## Gateway determination report – PP-2024-2184

913-925 Punchbowl Road and 21-23 Canterbury  
Road, Punchbowl

Published by NSW Department of Planning, Housing and Infrastructure

Figure 6: Current (left) and proposed (right) height of building map (Source: Planning Proposal)\*

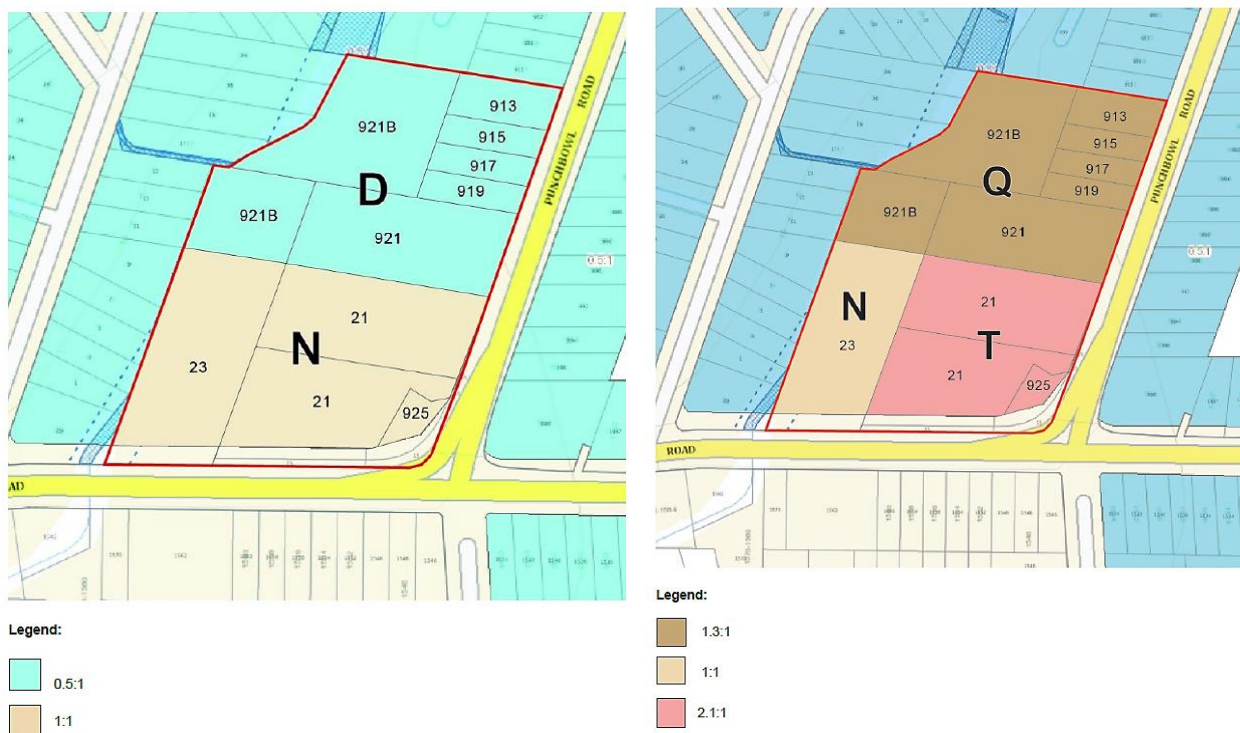
The map showing proposed building height controls is unclear. The proposed height controls for and associated legend need to be updated to clearly show the proposed building height controls.

Gateway conditions are recommended to update the maps to correct the errors in relation to existing and proposed controls.

- d) correct errors in relation to current and proposed Height of Building controls including inconsistencies in associated maps
  - e) clarify Gross Floor Area and Floor Space Ratio figures and address discrepancies between the concept scheme and proposed development controls

Figure 9: Flood Hazard Post Development 1% AEP (Source: Peer Review of Flood Assessment, Stantec)

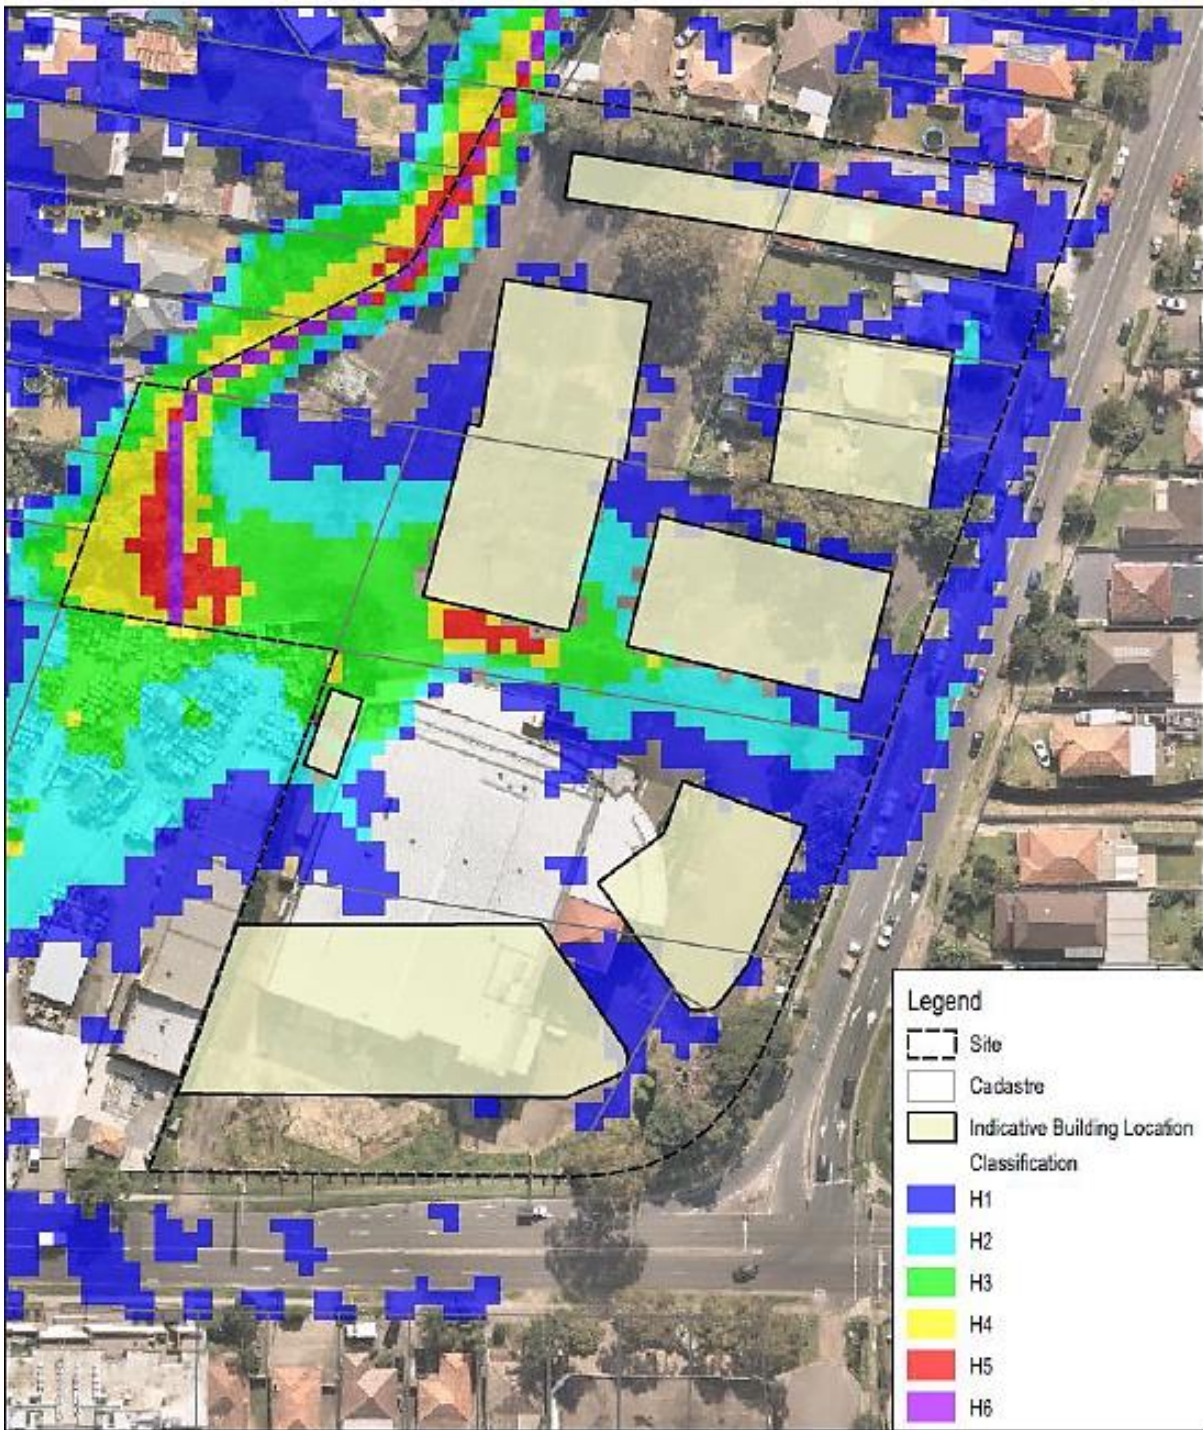
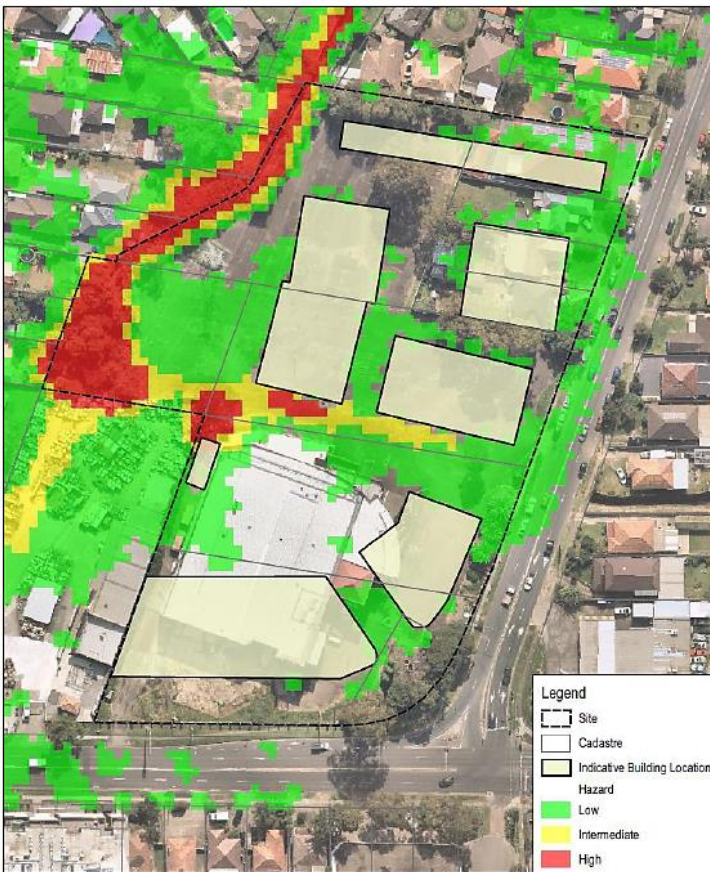
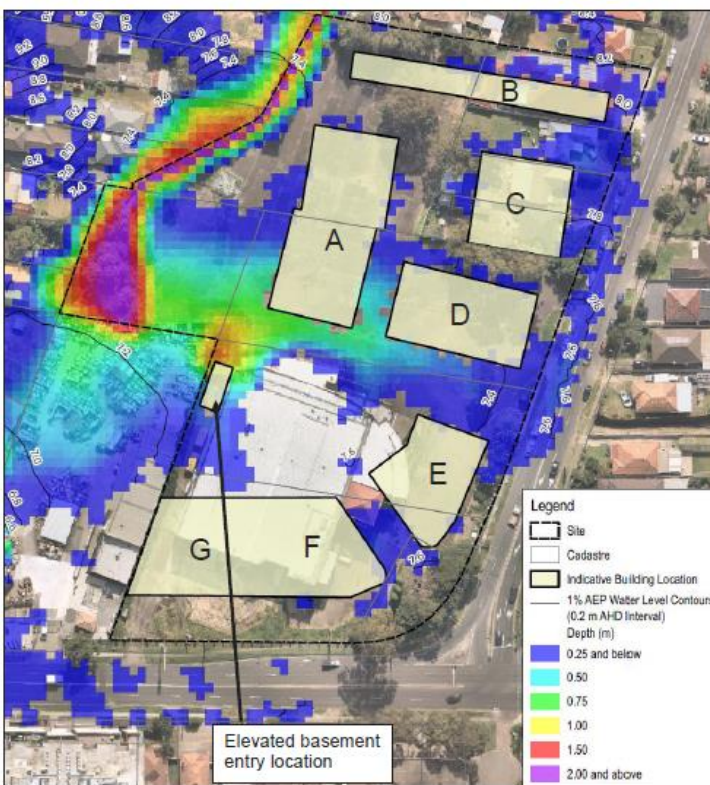
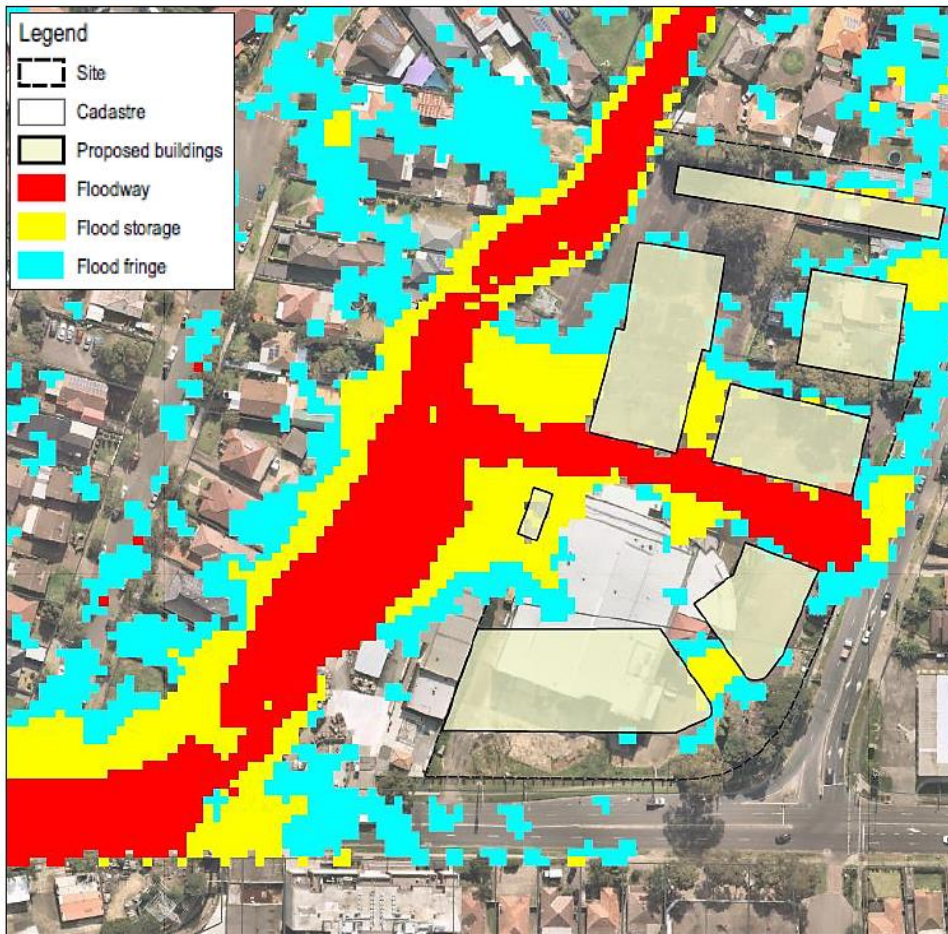
- the model set-up is found to be appropriate for the purposes of a planning proposal flood assessment
- the site is located within a flood planning area and is affected by mainstream flooding from the existing open stormwater channel that runs along the north-west boundary of the site in a southern direction. The site is also affected by post development hydraulic hazards ranging from H1 (no restrictions) to H6 (high hazard) (**Figure 8**)

A high-level review of the local flood model for 23 Canterbury Road show that the western side of the 23 Canterbury Road site is affected by 1% AEP floodway, therefore any potential buildings within this portion of the site may cause flow blockage and significant impacts. The eastern portion of the site is mostly flood-free in the 1% AEP and therefore may be suitable for potential development. The majority of the site, including the western portion is affected only by low or intermediate provisional hazard meaning that potential development may be suitable as it relates to flood hazard in the 1% AEP.

- H1 hazard is expected in the 1% AEP at the area adjacent to the driveway (**Figure 8**)
- H3 hazard is expected in the 1% AEP within the central road reserve with isolated areas of up to H5 hazard near Building A (**Figure 8**)
- the 1% AEP high hazard has been maintained through the centre of the site through the alignment of the central road proposed. There is high hazard close to Building A and D. The addition of design surface to modelling in later stages is expected to be able to address this proximity to high hazard subject proposal is supportable on transport planning grounds (**Figure 9**)
- the results show that the central road proposed for the site is within a key floodway in the 1% AEP as well as the western side of the site for the northern flowpath (**Figure 11**). While Building A and Building D are both near the floodway of the central road, civil design of the

- delete 23 Canterbury Road (Part B – Council initiated part) from the planning proposal due to insufficient information
- update the planning proposal to address consistency with Ministerial Direction 4.1 Flooding and update the flood assessment to address:

- the recommendations of the Peer Review of Flood Assessment (March 2024)
  - the additional permitted uses
  - evacuation and feasibility
  - where shelter in place is proposed, the following is addressed: time to flood peak and duration of the flooding and/or duration of isolation, suitable area identified above the PMF level in relation to shelter in place, advice from a suitably qualified engineer that the shelter in place location will be structurally sound

- g) address consistency with Ministerial Direction 4.1 Flooding and provide an updated flood assessment that addresses:
    - i. the recommendations of the Peer Review of Flood Assessment (March 2024)
